AGENDA FOR REGULAR MEETING VILLAGE OF TINLEY PARK PLAN COMMISSION

SOUTHWEST CHICAGO CHRISTIAN SCHOOL – 17171 84TH AVENUE WORKSHOP: SITE PLAN APPROVAL, VARIATIONS

PLAN COMMISSION STAFF REPORT-Workshop

Site Plan Approval,
Variations

Transportation
Facility
Landscape Plan

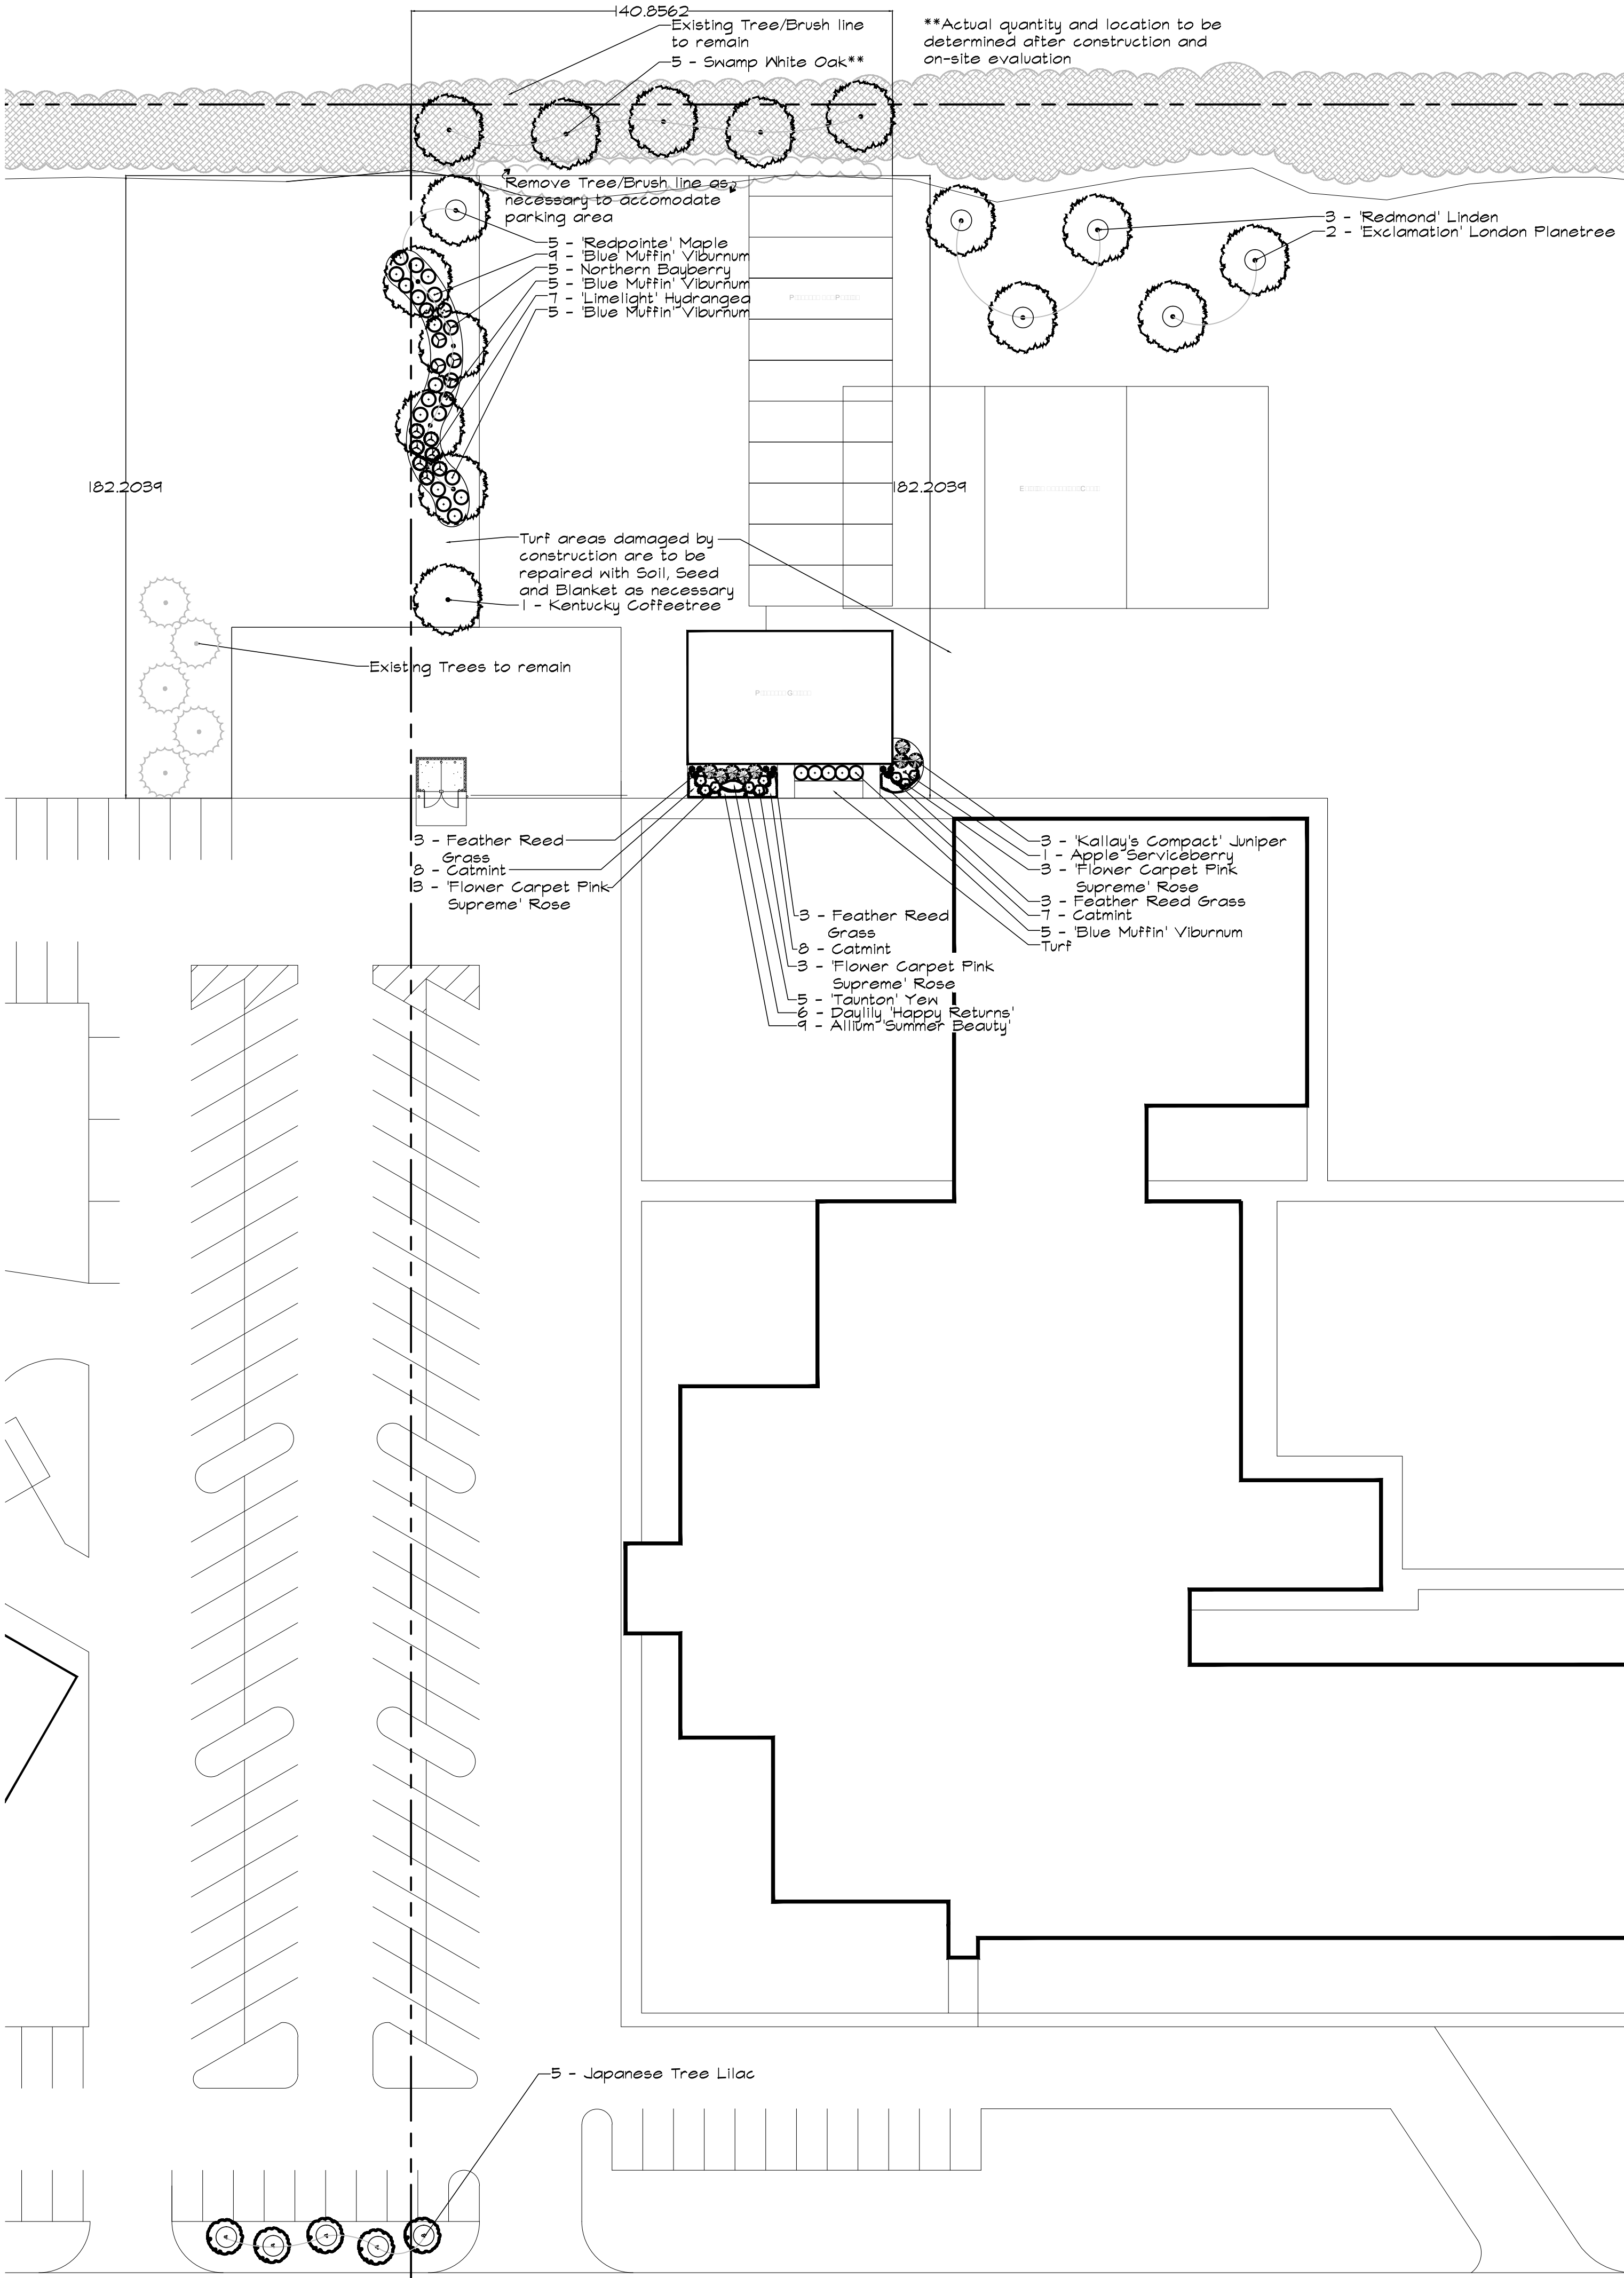
- Section 158.09 of the Municipal Code requires any special use proposed in R1-R4 districts to be separated from any residential lot by a Class C bufferyard. A Class C bufferyard has been shown on the north side, but has not been shown on the east or south sides. The following is suggested for the south and east bufferyards:
 - South – due to the large stand of existing vegetation on the south property line, and the distance from the special use to the south property line (~900'), these buffer plantings could be scaled back without visually detracting from the campus. It is recommended that only the canopy tree plantings be installed. This is reflected in the table below.

- East – the landscape plan recommends “remove tree/brush line as necessary to accommodate parking area.” To ensure some buffer exists, it is recommended that only the canopy tree plantings be installed. This is reflected in the table below.

2. Section 158.20.1(b) of the Municipal Code requires all parking to be screened from the view of adjacent properties and streets by plantings, berming or low fence/wall. This has not been shown on the landscape plan. If bufferyard plantings are installed as recommended above, this requirement could potentially be avoided given the existing character of the campus. See Image A below for suggestion on how to compensate for not requiring these plantings

3. Section 158.20.1(i) of the Municipal Code requires at least 15% of the parking lot shall be covered by landscaping. This has not been shown on the landscape plan. Given the use (bus parking), requiring islands to achieve this 15% could potentially be avoided.

4. Section 158.14.10 of the Municipal Code requires a 10' wide landscape area to front 70% of the side of all buildings which front dedicated streets (in this case, the north building elevation). This has not been shown on the landscape plan. Given that this façade has a vehicular service door, a pedestrian doorway, and this façade is significantly setback from 171st Street (~500'), requiring these plantings could potentially be avoided.

Applicant’s response: *The landscape design has been revised to show the **canopy trees on the south**. The feasibility of **adding trees to the east** may need to be verified at the time of construction. The School is not opposed to adding trees, but does not want to commit to cutting down existing trees in order to plant new trees. We would propose coordinating the final planting with the Village once we see what is left and the condition of the existing landscape screen after parking lot installation.*

Applicant's response: *The School is not opposed to adding landscaping as part of this project, however 1 and 1/2 of the parking islands noted to be improved are on the Church property not the School. The School can approach the Church to see if they desire this improvement or would allow it, however the outcome of that is unknown. From a functional standpoint not having a curb on these islands does allow for more flexibility with bus maneuvering. We would propose adding some planting equal to the amount that would go in the suggested islands along the 82th Ave. parkway instead. (Circled in Green above).*

Applicant's response: *We would agree this is not desirable; this is a bus parking area not a typical parking lot open to the public.*

Applicant's response: *The landscape plan has been revised to show some low planting along the west elevation of the building. We feel this will help integrate the building into the campus and help to address the concerns raised by Planning regarding the architectural interest of this elevation.*

Staff has reviewed the revised landscape plan and finds it addresses the deficiencies of the first submittal and meets the intent of the Landscape Ordinance. Staff recommends making any final approval of the Site Plan on Staff's field inspection after construction.

1 FLOOR PLAN 1/8" = 1'-0" 2,400 SF

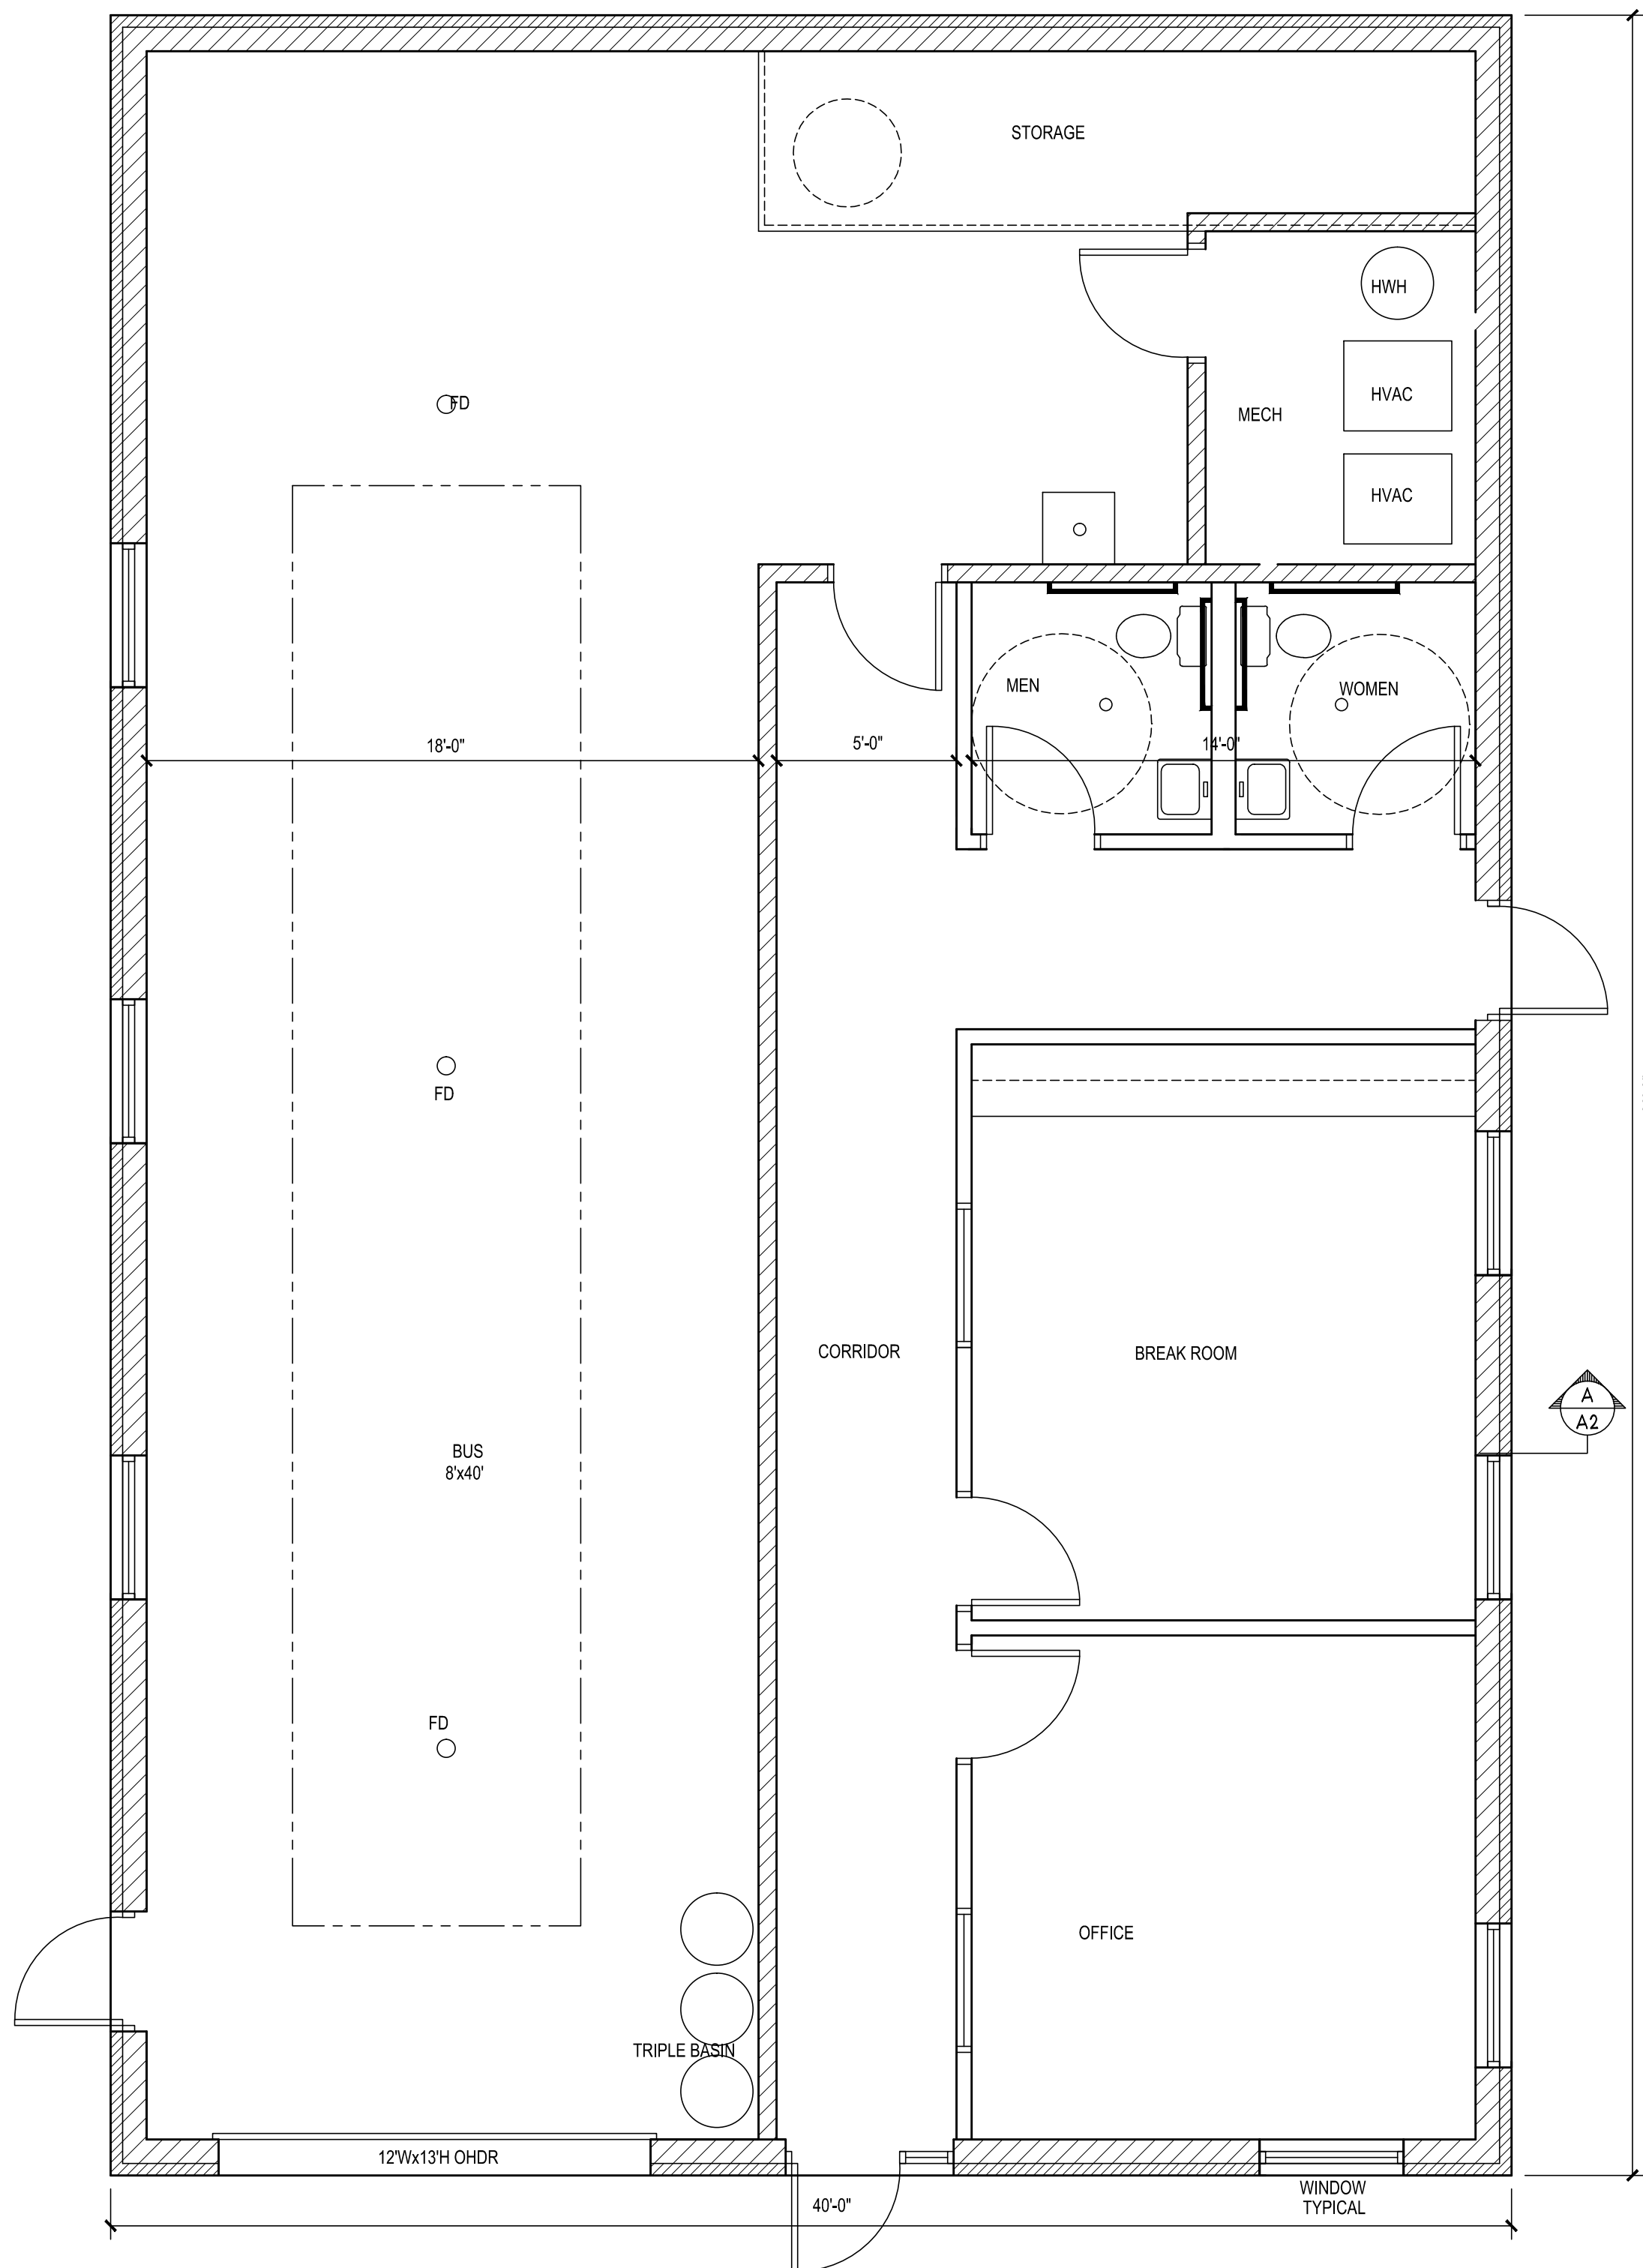
3. Please clarify where HVAC and other utilities used for the proposed building will be located. All units must be screened from view.

Please refer to the floor plan on Sheet A2 where the HVAC equipment is noted as internal to the building. We do not expect to have any HVAC equipment on the roof.
